20 Albert Terrace Mews London NW1 7TA – MR Andrew Cowan
Application no: 2017/0705/P FOR A BASEMENT

20 Albert Terrace Mews Basement Planning Considerations

20 Albert Terrace Mews Basement Planning Considerations - **STRUCTURAL**

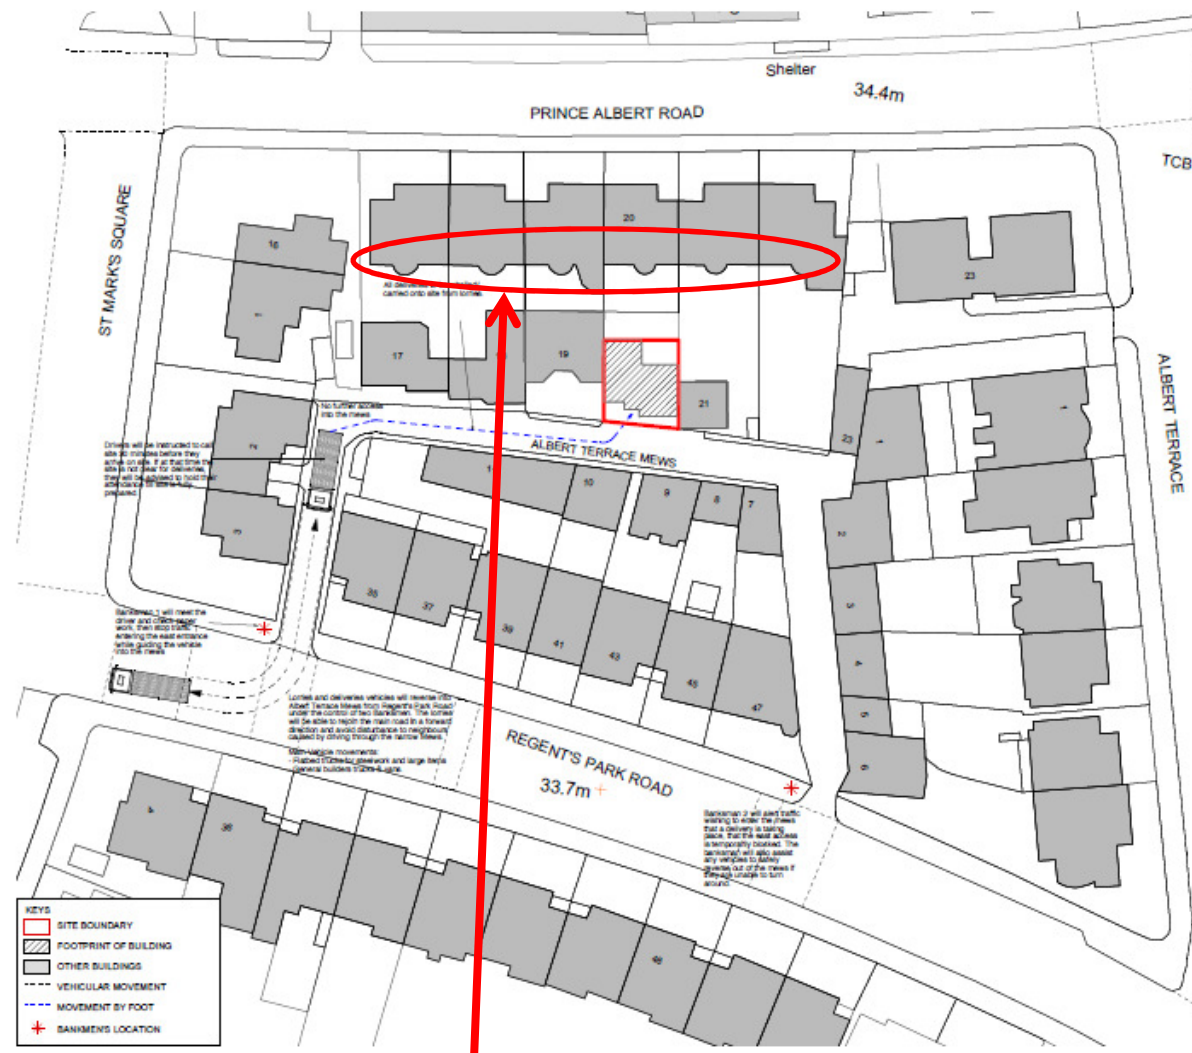
17 PAR has severe subsidence to the East side. This has resulted in previous mortgages being denied.

19 PAR has been partially underpinned

20 PAR has a large crack approx 2.5m through the rear bay

Redesdale House garage has been effected by subsidence

20 ATM when first constructed suffered cracking & had to be repaired

3 SMS recent movement & cracking to flank wall

21 ATM the most recently constructed mews & was built with a basement. This needs continual pumping to avert flooding

35 RPR recent movement & cracking to flank wall

History of clay heave in this area

10 ATM "Our house at no 10 has suffered from severe subsidence and had to be underpinned."

20 Albert Terrace Mews Basement Planning Considerations - **STRUCTURAL**

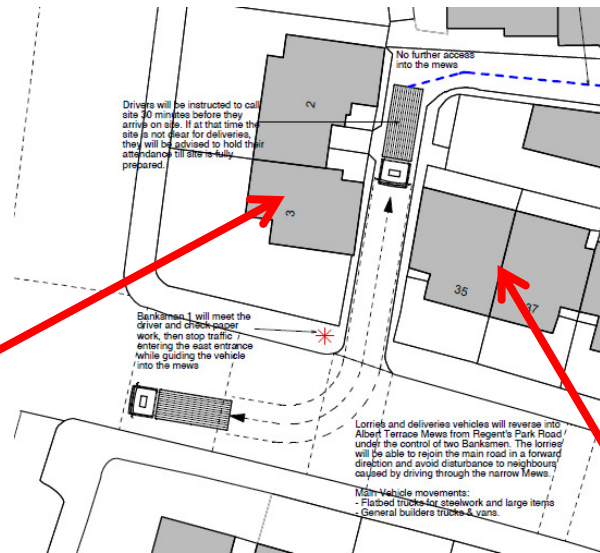
It is claimed by the applicant that these buildings have basements. That is not true, they have lower ground floors which are level with the gardens & the ground floors of the mews. The proposed basement would be much lower than the surrounding properties, except 21 ATM which has a problem which the owner is happy to testify to.

20 Albert Terrace Mews Basement Planning Considerations - **STRUCTURAL**

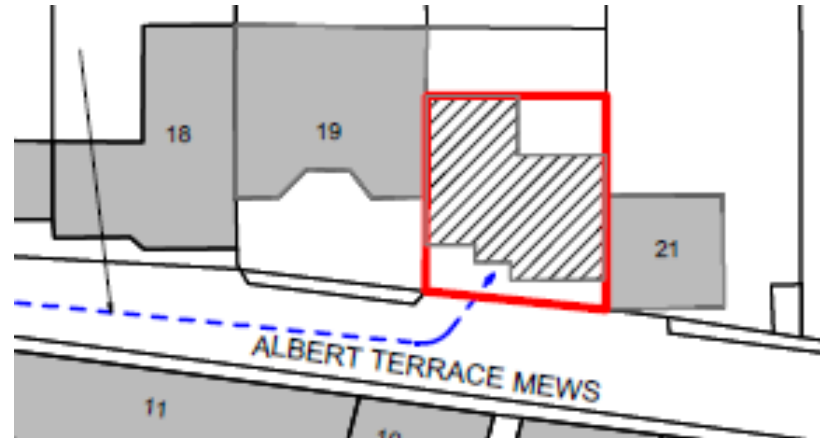
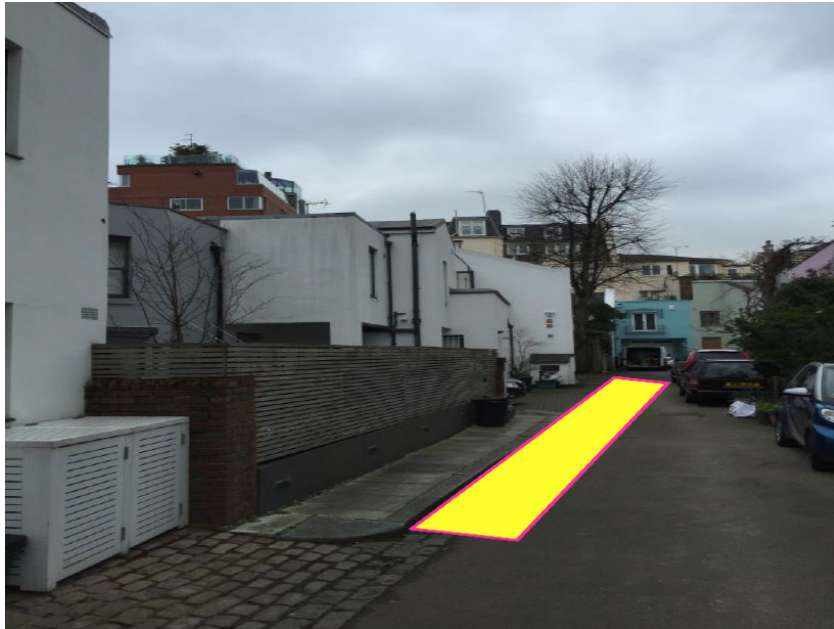
3 SMS neighbours report on the effects of recent works in the mews
"I live on the corner of St Marks Square and Albert Terrace Mews. Myself, and my upstairs neighbours..... believe that the work damaged our property externally as there is substantial cracking to the structure of the property."

35/37 RPR neighbours report on the effects of recent works in the mews.
"The recent work in Albert Terrace Mews.... The heavy lorries going down the side of 35 Regent's Park Road, which forms part of the freehold company with this house, caused cracks in the walls of the house and contributed to the recent subsidence, which has caused us to pay house insurance of £20,000 a year."

Either side of where the applicant proposes to bring in heavy lorries & materials

20 Albert Terrace Mews Basement Planning Considerations - **STRUCTURAL**

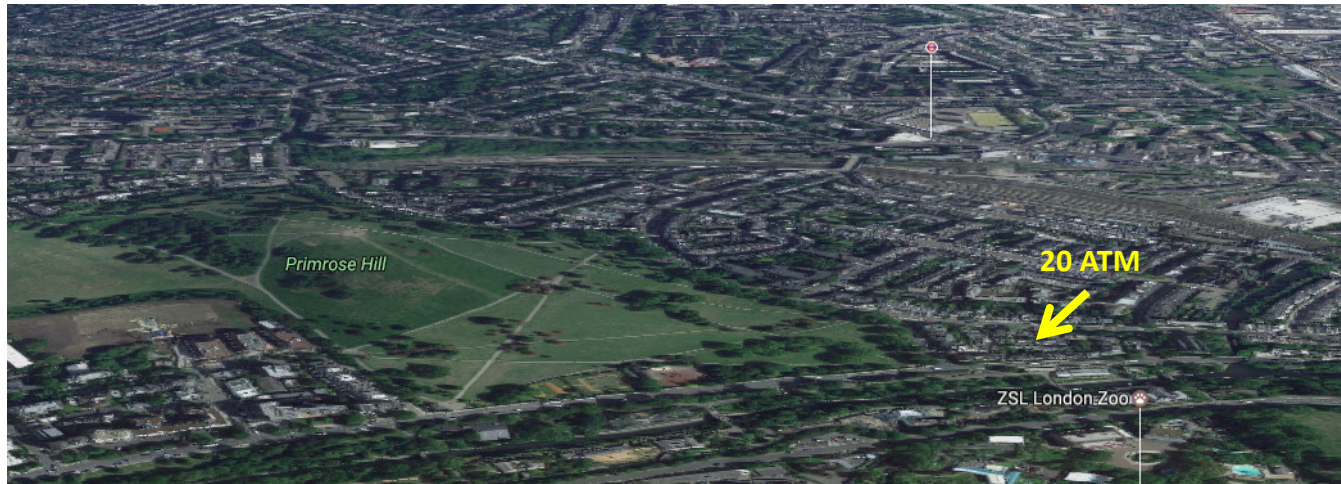
The road would have been originally designed & constructed in circa 1850 for horses & carriages serving the surrounding houses it has in recent years been subject to building traffic with the following reported consequences:-

“Please look at A.T Mews road outside no 21 where the road is at a lower level. This was caused by building of Mews house at 21 which is on site of prev garden with other trees. I had to contact Camden building control as the site was so unstable that the road was in danger of falling into the hole.

The road looks In a pretty unstable state now.

.....Since that time the parking area next to 19 on no 20 site became unlevel and there were 3/4 areas where there were obvious dips in the surface. I mentioned this to Camden when we were having discussions re other developments in the Mews. This area was levelled some months ago and the blocks forming the parking surface were put back as if nothing was untoward.”
